Reference: L-2024-051816-A

Subject: Invenergy Clear River Energy Center
Facility Noise and Community Noise Impacts

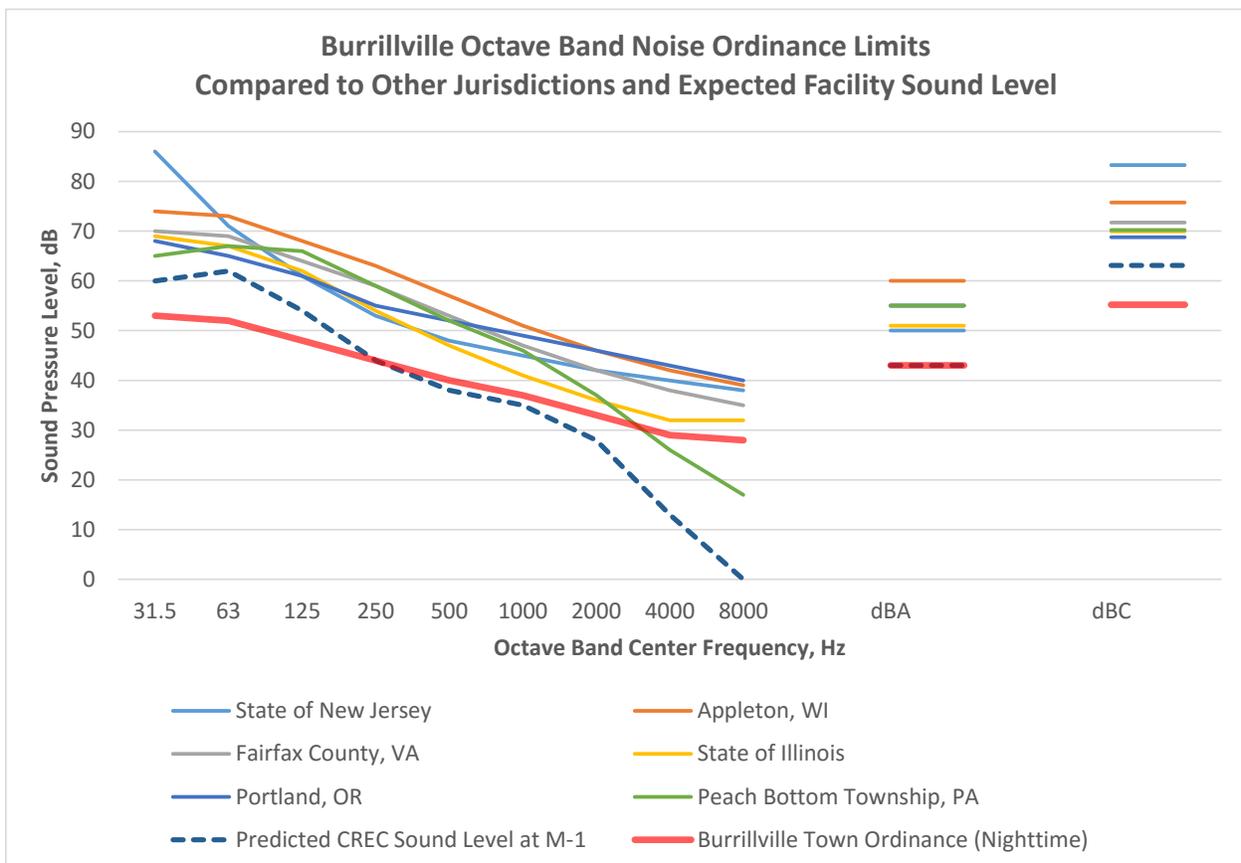
In addition to this it is important to realize that the octave band limits contained in the Town Ordinance, especially in the lower frequencies, are well below all the other octave band regulatory limits that we're familiar with. The chart below shows a series of nighttime octave band noise limits from a variety of jurisdictions compared to the Town's limits (thick red line).

This graphic shows that the Town's limits are well below what might be considered the norm, but, more to the point, there is no actual need for the limits to be this low. The expected plant sound level at the closest residences is shown as the blue dotted line. Although it's not intuitively obvious, the plant would not be any less audible or sound any quieter if its sound levels in the three lowest octave bands were equivalent to the Ordinance rather than over the limits as currently predicted because, in a nutshell, the human ear is not very sensitive to frequencies below about 200 Hz, so the facility would effectively sound the same either way. In fact, subjective audibility is basically quantified by the overall A-weighted sound level and both the Ordinance spectrum and the plant sound spectrum in the chart both total up to 43 dBA, indicating that the sounds are of the same subjective magnitude. This overall limit of 43 dBA fully serves the purpose of limiting the project's noise to an acceptable level in the community. Invenenergy has repeatedly argued that it is not feasible to meet the lower octave band limits and they have asked for a waiver on the octave band requirements. This is a legitimate assertion and a legitimate request. We would agree that it is probably technically impractical - and would add that it would do nothing to reduce the subjective audibility of the plant if it were.
